# City of Napoleon

To John Herl - Mack Industries  
Fax No. (419) 354-4153  
From Adam C. Hoff, P.E. *ACH*  
Date June 23, 1997  
Subject Storm Manhole for Arrow Molded Plastics  
Pages 2, including this one

*To: Brent Damman - Building & Zoning  
Administrator*  
*From: Adam C. Hoff, P.E. - City Engineer* **ACH**  
*cc: Sonny Helberg, Jeff Marihugh*  
*Date: June 2, 1997*  
*Subject: LDM Technologies Site Plan Review*

To Jim Rupp - R&R Three, Inc.  
Fax No. (517) 567-4410  
From Adam C. Hoff, P.E. *ACH*  
Date May 29, 1997  
Subject LDM Technologies Site Plan  
Pages 2, including this one

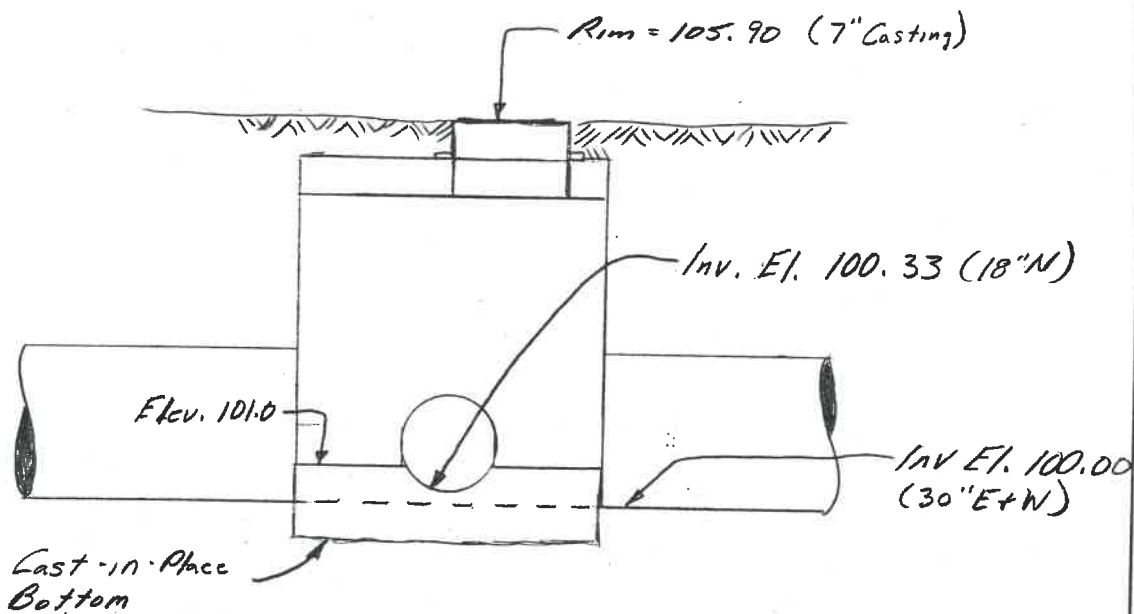
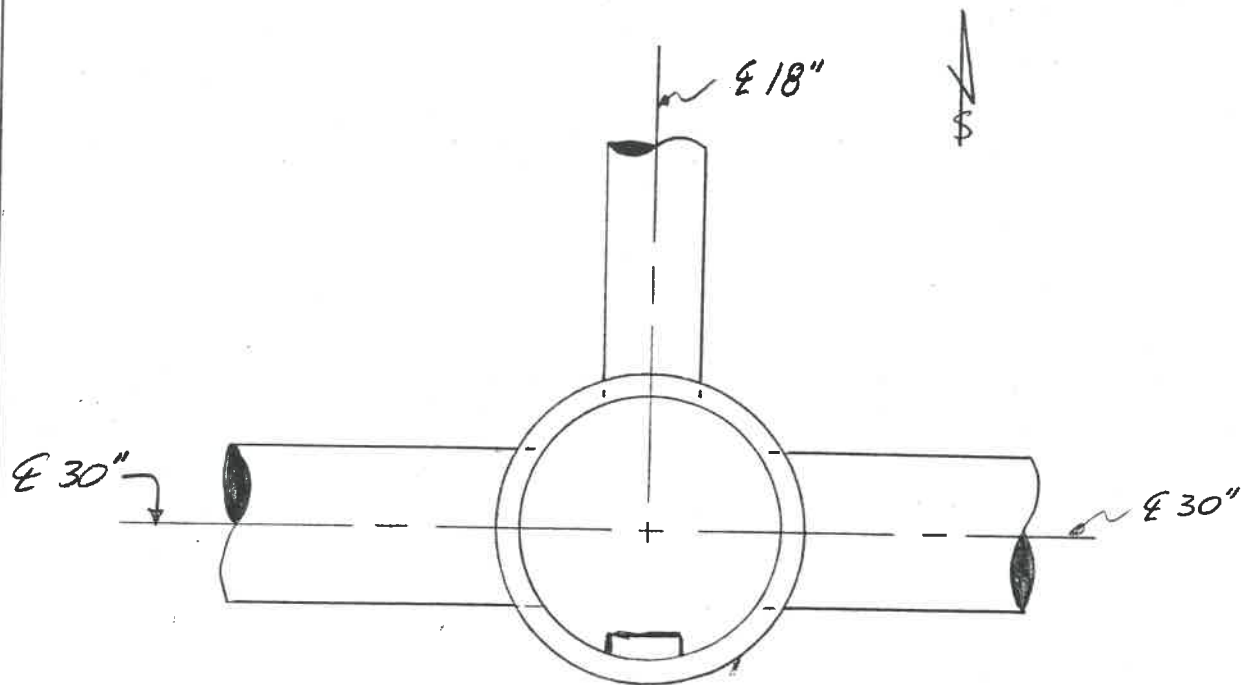
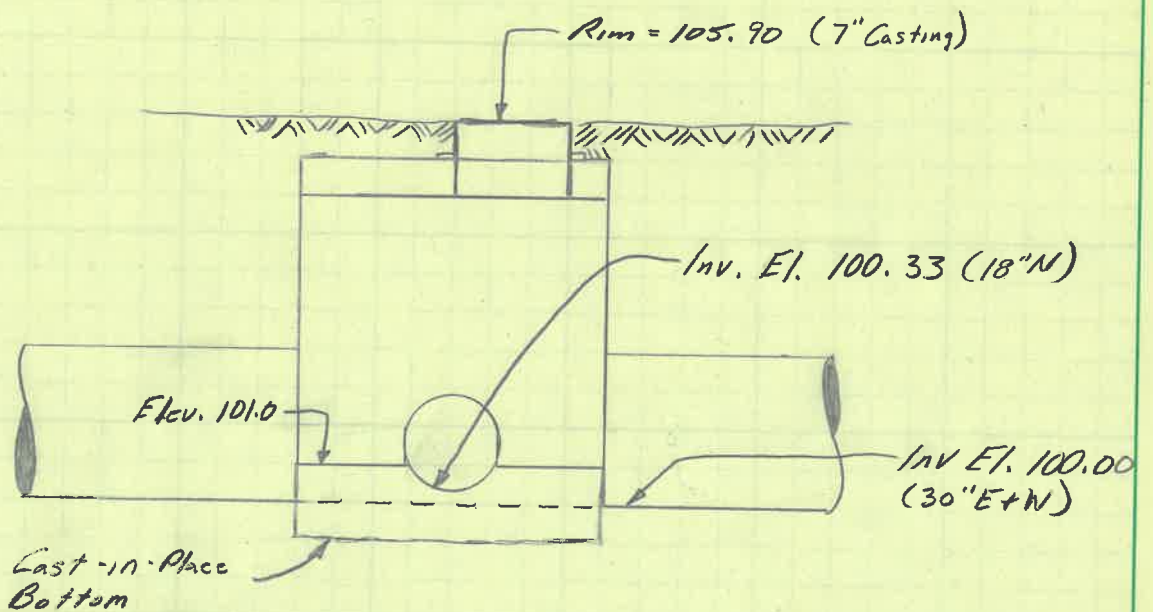
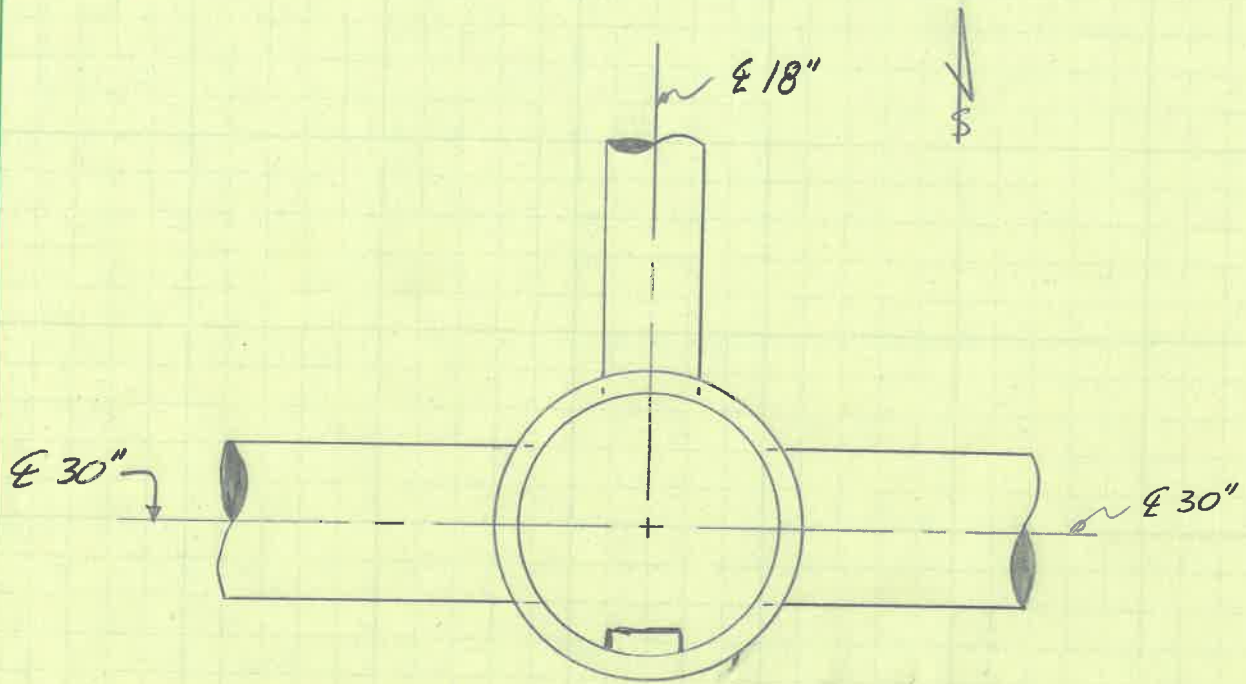
Per our conversation of this morning, please provide a manhole riser section and flat top to meet the attached sketch. I am assuming that a 5' dia. section will be required. Please let me know if this is incorrect. A cast-in-place bottom will be poured for the riser to sit on.

*Service connection ?*

\* ~~10" x 30"~~ MH Section w/ "doghouse" cuts for 2- 30" (E+W) and 1-18" (N) connections and steps on S. side.

\* ~~10" x 6"~~ Flat ~~stone~~ top.

\* ~~40" x 50"~~ MH Section w/ "doghouse" cuts for 2- 30" (E+W) and 1- 18" (N) connections and steps on S. side.

\* ~~48" x 60"~~ Flat ~~stone~~ top.
